Symptom - Engine - Engine is Sluggish When Revving Up/Maximum Speed is Not Reached: Checking Part Number of Throttle-housing Cover (SY 104/19)

Vehicle Type: **911 GT3**

Model Year: **As of 2018 up to 2019**

Subject: **Throttle-housing cover**

Throttle-housing cover

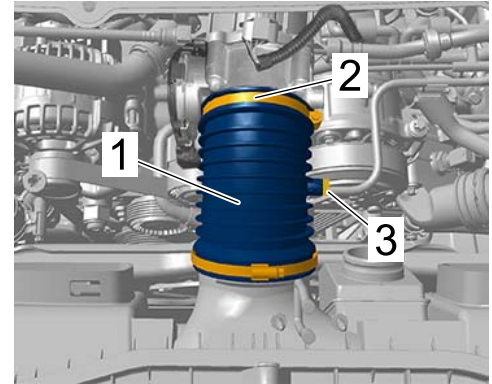
Symptom: The vehicle does not reach maximum speed and the engine is sluggish when revving up at speeds of more than 7,000 rpm. The yellow warning message **"Reduced engine power – Driving permitted"** can also appear in the instrument cluster.

Cause: The cover between the air cleaner housing and throttle housing can become deformed due to insufficient material hardness while driving.

Work Procedure: 1 Check part number ⇒ *Throttle-housing cover -1-*.

Remedial Action: Check part number of throttle-housing cover and replace it with an optimized cover if necessary.

- 1.1 Replace throttle-housing cover with Part No. **99111027091**, see ⇒ *Workshop Manual '242519 Removing and installing air cleaner housing'*.
